October 24, 2006

SUBJECT: Calvert Cliffs Nuclear Power Plant
Unit Nos. 1 & 2; Docket Nos. 50-317 & 50-318
Core Operating Limits Reports for Unit 1, Cycle 18, Revision 3 and Unit 2,
Cycle 16, Revision 1

UNIT 1, CYCLE 18, REVISION 3

UNIT 2, CYCLE 16, REVISION 1

Figure 3.2.1-3

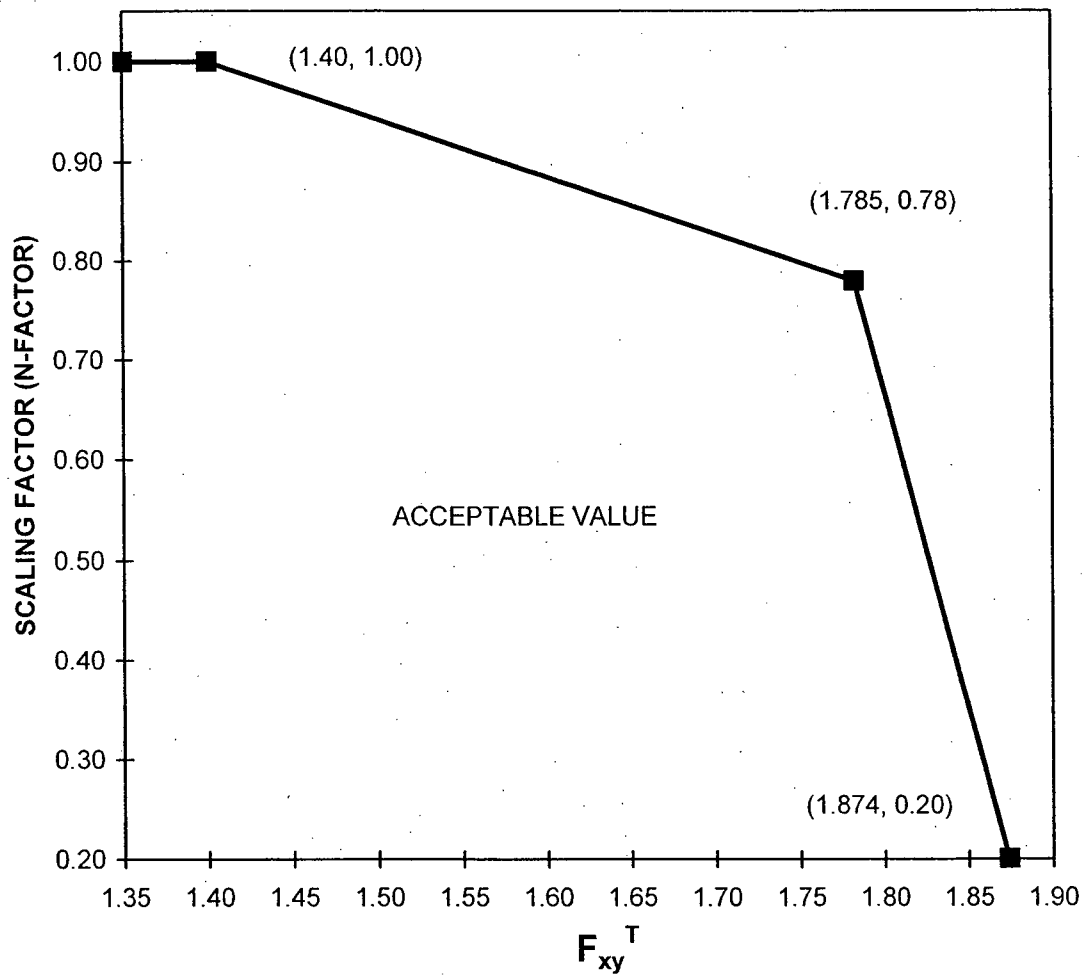
Revised Figure 3.2.1-3 (N-Factor) as part of the corrective action for IRE-017-571.

Figure 3.2.1-3

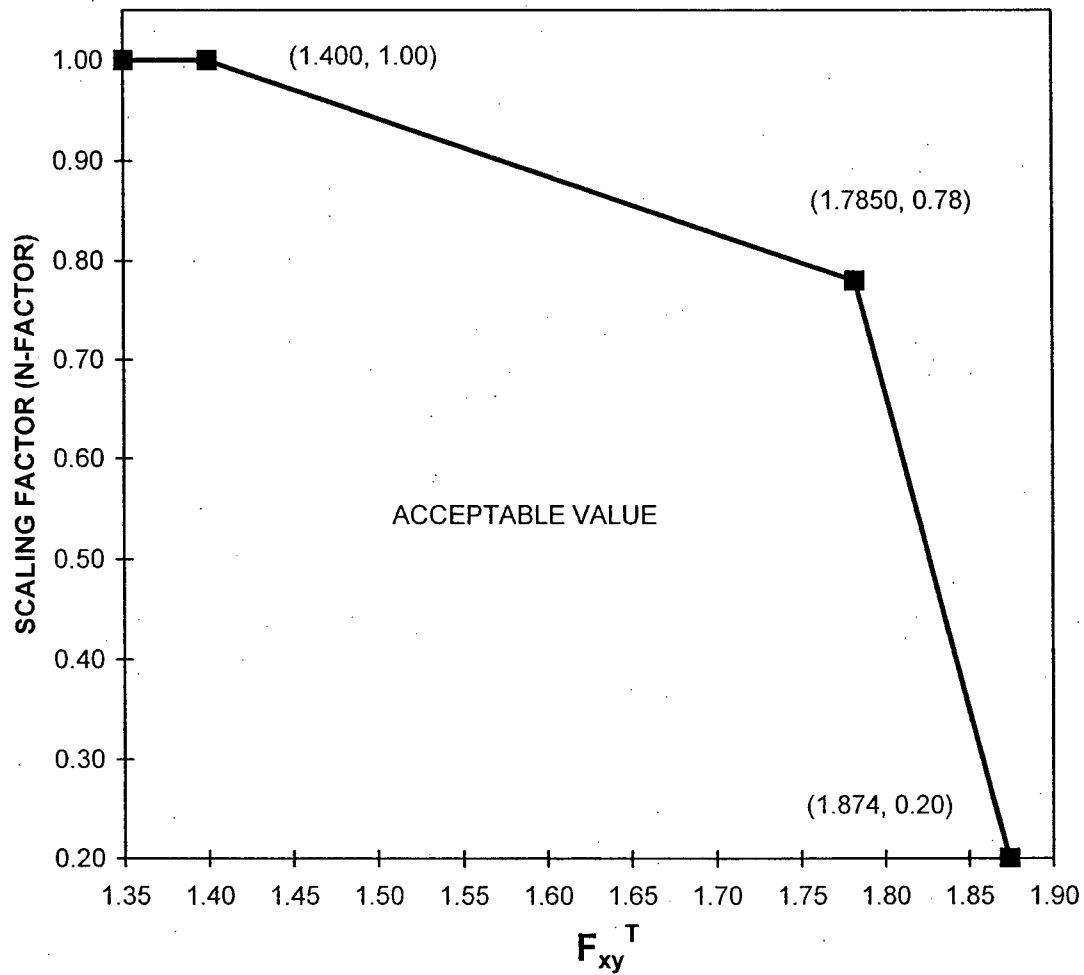
Revised Figure 3.2.1-3 (N-Factor) as part of the corrective actions for IRE-017-571.
